11758V-01

S E R V I C E N O T E

HP 11758V Digital Radio Test System

11757B-02 Modification Diagram

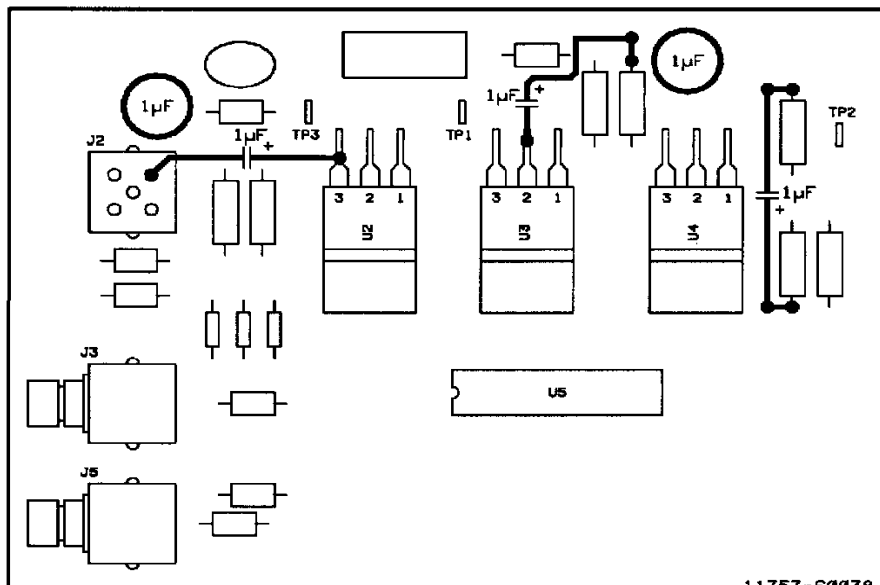
Some spurs 50KHz - 300KHz offset from the carrier, greater than the -67dBc specification for the RF source were observed on a few production units (11758). The problem was isolated to the EEPROM/Counter Board, both the current (11757-60056) and older (11757-60038) assemblies, on the U2, U3, and U4 regulators. The fix was to add 1uF capacitors to the input and output of the regulators as described in the regulator's application notes. This makes the regulators optimally stable and eliminates oscillations which were causing the spurs on the RF source's signal. The older board (11757-60038) can be retrofitted with a field installable modification (described in this service note) rather than replacing the board with its direct replacement, the Counter/EPROM Upgrade Kit (11757-60059). This eliminates the need to scrap the old board and order both the new board and new firmware contained in the kit. The updated older board (11757-60038) will become 11757-60061 after the fix is implemented. Similarly, the 11757-60056 can be modified and would become 11757-60060.

5. Unsolder opposing leads of R30 and R10 (see diagram) and solder post connectors into both locations. Re-attach respective leads for R30 and R10 as well as leads for a 1uF electrolytic capacitor (0180-4129). Make sure polarized (plus) end of the capacitor goes to the R30 lead.

6. Attach the polarized (plus) lead of a 1uF electrolytic capacitor (0180-4129) to pin 3 of U2 and solder it. Remove the solder from the J2 ground hole indicated on the diagram, insert the remaining capacitor lead and solder.

1. Place board on a bench equipped with an ESD mat. Make sure person performing this modification is grounded also. Observe all normal ESD precautions while this procedure is being followed.
2. Make sure that all exposed capacitor leads are covered with the insulating tubing to prevent contact with other points on the board.
3. Attach the non-polarized lead from a 1uF capacitor (0180-4129) to pin 2 of U3 and solder it.

4. Unsolder the lead of R7 closest to the edge of the pc board and solder a post connector into the hole. Re-attach R7 to the post as well as the polarized (plus) lead of the 1uF capacitor that was soldered to U3 pin 2.

7. Remove both capacitors C11 and C9 and replace with 1uF capacitors (0180-3771). Note that since these are three-lead items, it does not matter which way the capacitors are oriented.
